**SUBDIVISION REVIEW SHEET****CASE NO.:** C8-2021-0152**COMMISSION DATE:** October 25, 2022**SUBDIVISION NAME:** Pinnacle at Wildhorse Ranch Preliminary Plan**ADDRESS:** 12000 Blue Bluff Rd**APPLICANT:** Texas WH200 LP**AGENT:** Kimley-Horn and Associates (Kevin Burks)**ZONING:** Wildhorse Ranch PUD**NEIGHBORHOOD PLAN:** Wildhorse Ranch PUD**AREA:** 60.06 acres**LOTS:** 57**COUNTY:** Travis**DISTRICT:** 1**WATERSHED:** Gilleland Creek**JURISDICTION:** Full Purpose**SIDEWALKS:** Sidewalks will be constructed along all internal streets and the subdivision side of Blue Bluff Road.**VARIANCES:** Variances from LDC § 25-8-341, to allow cut to 15 feet, and LDC § 25-8-342, to allow fill to 15 feet.**DEPARTMENT COMMENTS:**

Exhibit B  
PRELIMINARY PLAN  
FOR  
PINNACLE AT  
WILDHORSE  
RANCH  
CITY OF AUSTIN,  
TRAVIS COUNTY, TEXAS

CITY OF AUSTIN –DEVELOPMENT SERVICES DEPARTMENT  
SUBDIVISION APPLICATION – MASTER COMMENT REPORT

**CASE NUMBER:** C8-2021-0152  
**UPDATE:** U2  
**CASE MANAGER:** Juan Enriquez, Senior Planner [juan.enriquez@austintexas.gov](mailto:juan.enriquez@austintexas.gov)

COVER SHEET

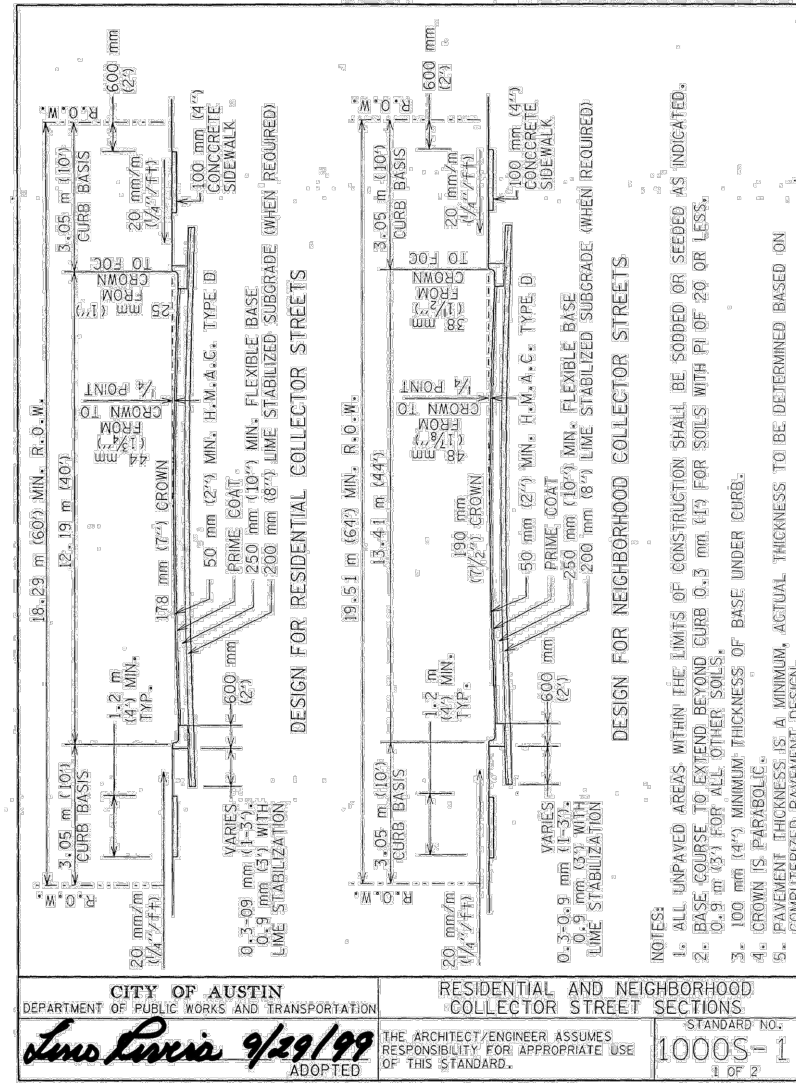
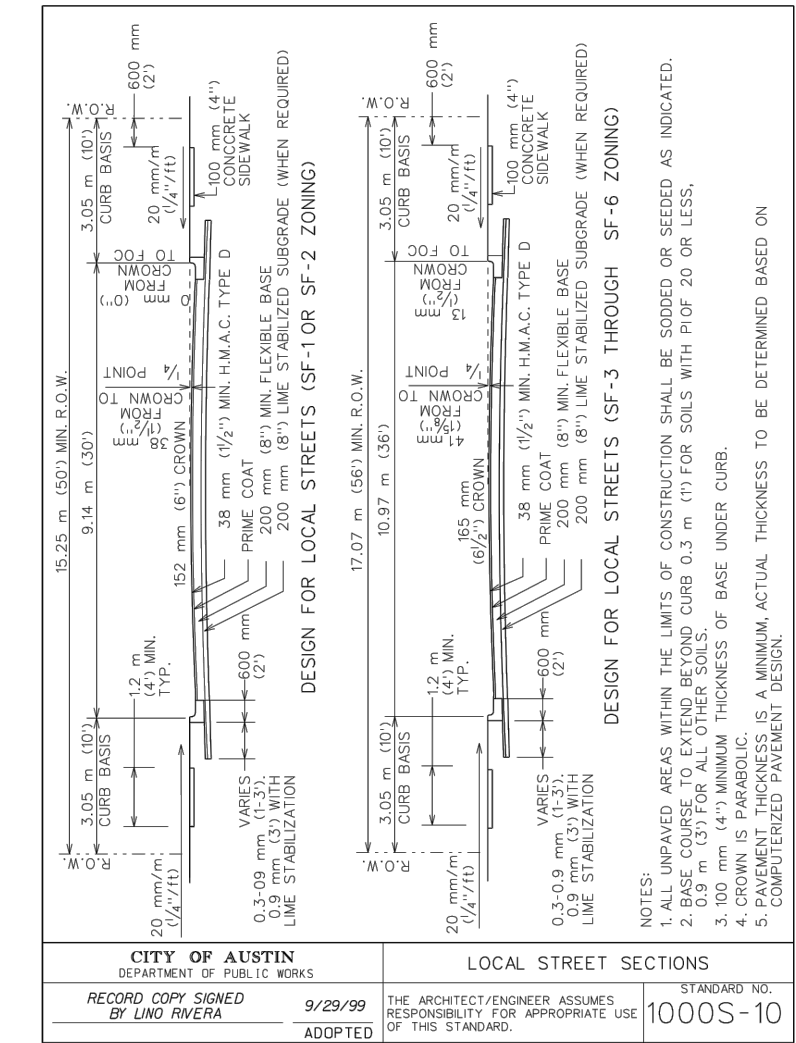
- ATD 2. Revise “sidewalk location” in the street table to just “sidewalk” and put the required widths in the column, according to street classification (4’ and 5’). Remove “back of curb”. TCM, Sec. 1.3.0.

ATD 5. Sidewalks are required on the subdivision side of BLUE BLUFF ROAD. Identify the location of the sidewalks by a dotted line on the preliminary plan. LDC 25-6-351. TCM, 4.2.1.

ATD 6. Add subdivision construction case number (C8-2017-0291.1B) to the WILDHORSE RANCH TRAIL (West of the roundabout).

U1: Comment remains. Please, change the location of the case number to the west of the roundabout. Previous comment had a typo.

- ATD 1. ATD transportation review fees as adopted by City Council will be added to AMANDA. These fees can be paid online on ABC portal.  
**U2: Comment cleared.**

**U1: Comment cleared.**

**U2: Comment cleared.**
